<b>Solicitation No. - N° de la demande</b>	<b>Amendment No. - N° de modification</b>
5P420-21-0188/A	<b>007</b>
PW-22-01002221

## Amendment 007

Annex C - Floor Plan(s) of solicitation 5P420-21-0188/A, titled “Office Furniture categories 1a, 2, 3, 5, and 6: Parks Canada Agency – Field, B.C.” is amended as included herein.

**a. Panel Matrix**

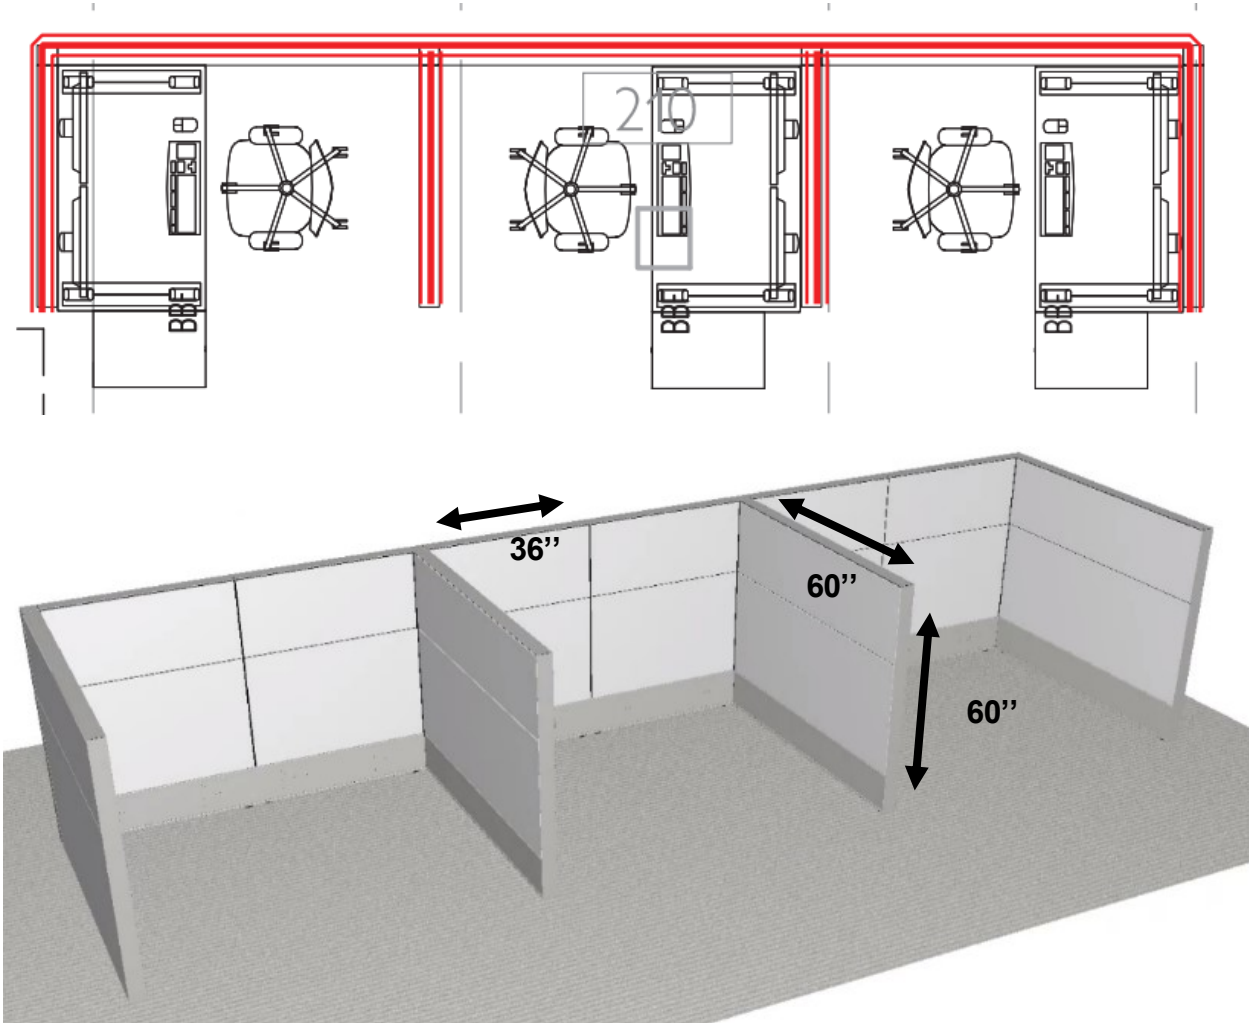
- Q1.** The note indicates that the workstations are 60”H x 60”W. the chart only shows 2 sizes, 60”W and 36”W. Based on the count, the base panels of 24”W base height, over panels and elements are missing from the table. Please provide correct count and a sketch with exact sizes would be helpful

- A1.** See changes below for clarification.
- Q2.** Also related to above. 60W notes as (3). the Worksurface privacy add on and seated privacy height frames are missing from the chart. Please clarify count

- A2.** See changes below for clarification.
- Q3.** Take note, pdf drawing shows the footprint to be roughly 72”W, discrepancy from the chart below. Please clarify size.

Under 3) Panel Matrix or Workstation Layout **DELETE** a. Panel Matrix in its entirety and replace it with the following:

**WORKSTATION PANELS - 3 DESKS IN MIDDLE OF ROOM (POWERED SPINE, FABRICTILES BACK TO BACK),  
DEMISING PANEL (FABRIC/FABRIC, NO POWER) 60'' H x 60'' L**

PAFRBHPB36	Frames / Cadres	Base Height / Hauteur de base	Powered outlet(s) Below Work Surface / Prise(s) électrique(s) au dessous de la surface de travail	914mm (36 in./po)	<b>Base of spine – 2 per desk</b>
PAFRSANP36	Frames / Cadres	Seated Privacy Height Add On / Panneau additionnel pour intimité en position assise	Non-Powered / Non- électrifié	914mm (36 in./po)	<b>Top of spine – 2 per desk</b>
PAELBHCPDFA36	Elements / Revêtement	Base Height / Hauteur de base	Cut-out(s) for Power & Data, Fabric / Cavité(s) finie(s) pour l'insertion de prise(s) électrique(s) et informatique(s), tissu	914mm (36 in./po)	<b>Add on to base of spine</b>
PAELSAxxxFA36	Elements / Revêtement	Seated Privacy Height Add On / Panneau additionnel pour intimité en position assise	Fabric / tissu	914mm (36 in./po)	<b>Panel finish for spine – 4 per desk</b>
PAFRBHNP60	Frames / Cadres	Base Height / Hauteur de base	Non-Powered / Non- électrifié	1524mm (60 in./po)	<b>Base for the divider</b>

PAFRSANP60	Frames / Cadres	Seated Privacy Height Add On / Panneau additionnel pour intimité en position assise	Non-Powered / Non- électrifié	1524mm (60 in./po)	<b>Add on for the divider</b>
PAELSAxxxFA60	Elements / Revêtement	Seated Privacy Height Add On / Panneau additionnel pour intimité en position assise	Fabric / tissu	1524mm (60 in./po)	<b>Panel finish for divider base</b>
PAELWAxxxFA60	Elements / Revêtement	Work Surface Privacy Add On / Panneau additionnel pour intimité à la surface de travail	Fabric / tissu	1524mm (60 in./po)	<b>Panel finish for divider top</b>
